MODIFICATION RECOMMENDED

6632B-09

**S E R V I C E N O T E**

Agilent 6632B DC Power Module

**Figure 1. A1 Board Layout**

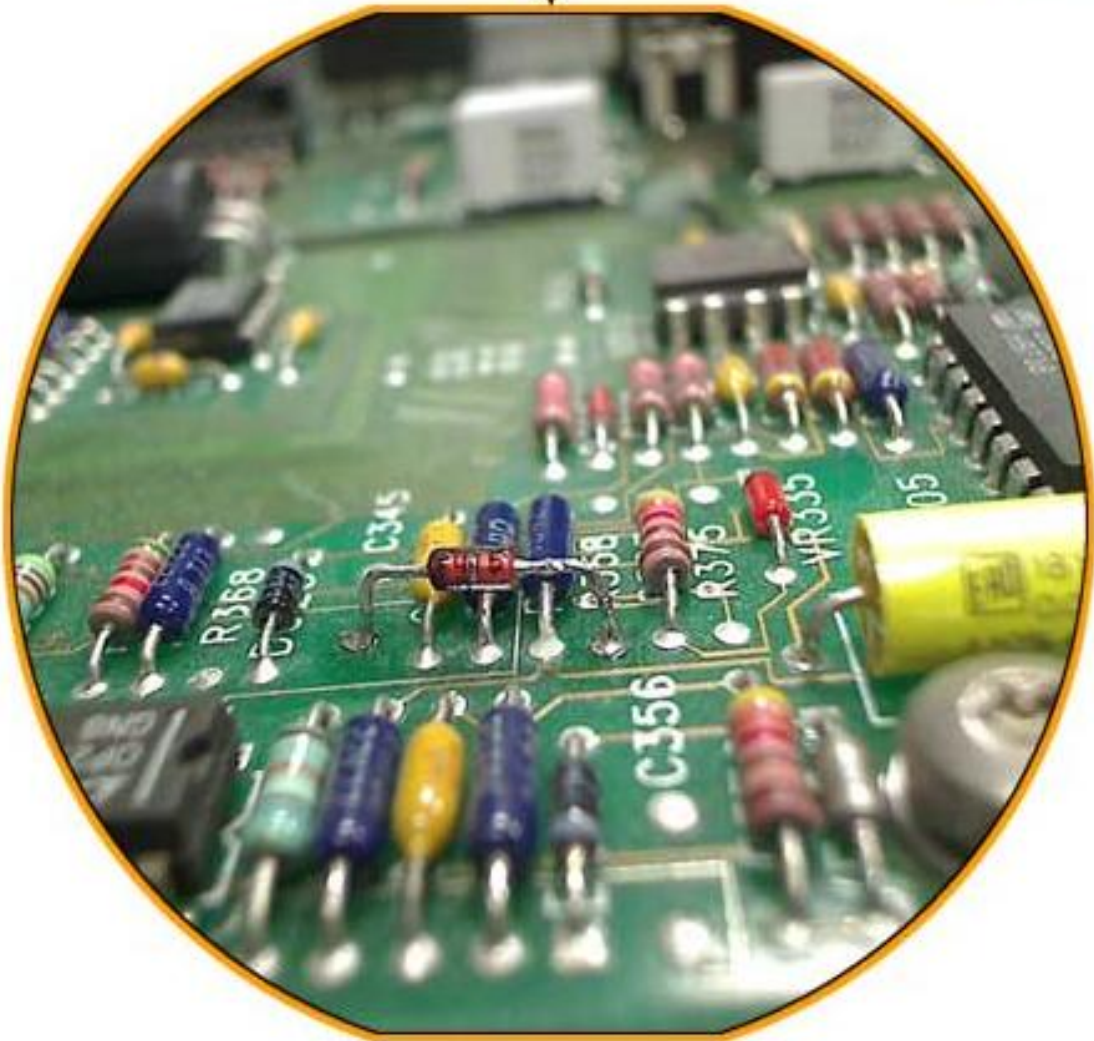
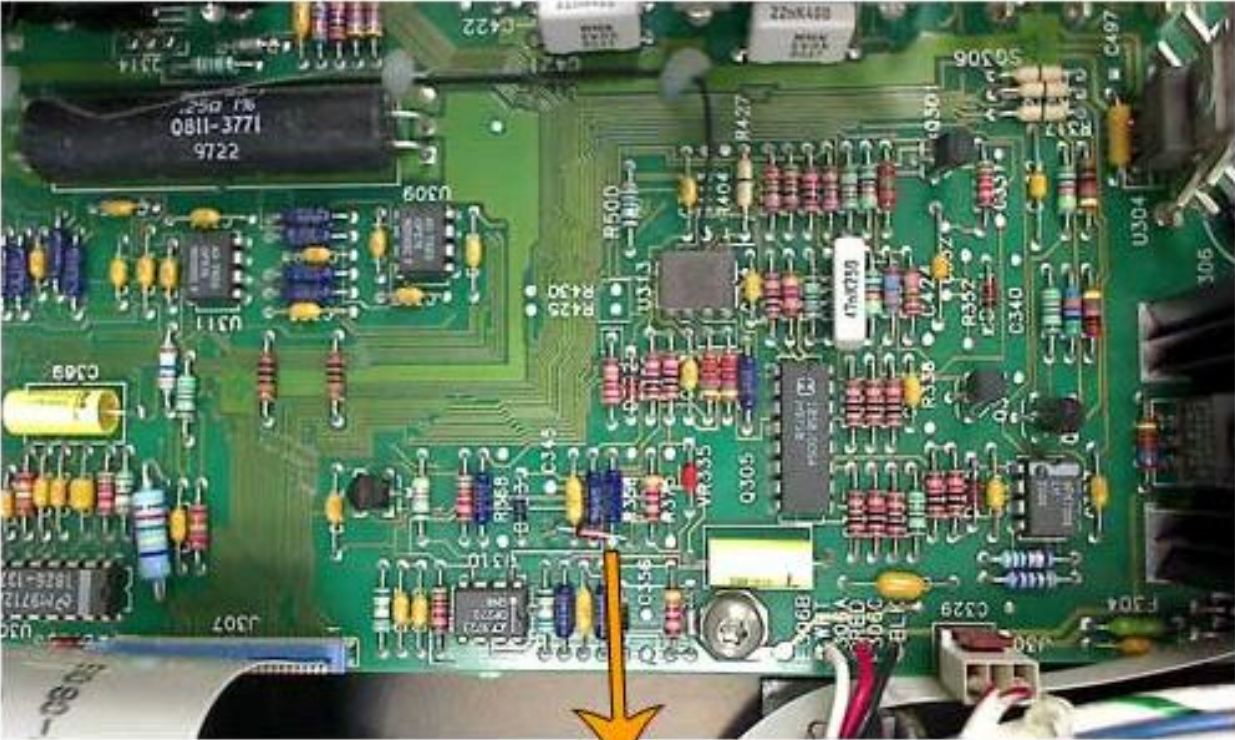
There is a possible glitch on the output due to an AC line sag between 23 VAC to 27 VAC. The time length of the glitch pulse is about 1.9s and the power supplied is 2.8W.

It is caused by a condition in which the current offset and voltage offset DACs do not reset, when the current and voltage programming DACs reset during an AC line sag. This results in an op-amp that normally operates at -5V DC to operate in the positive direction, and drives the output of the 6632B on.

The solution is to implement a diode (P/N 1901-1344) that clamps the op-amp to 0.7 V. This prevents the op-amp from driving the output on, and does not affect it due to a normal operation at -5V DC.

The figures below show where to solder the diode (P/N 1901-1344) from R358 to C345 on the A1 main board.
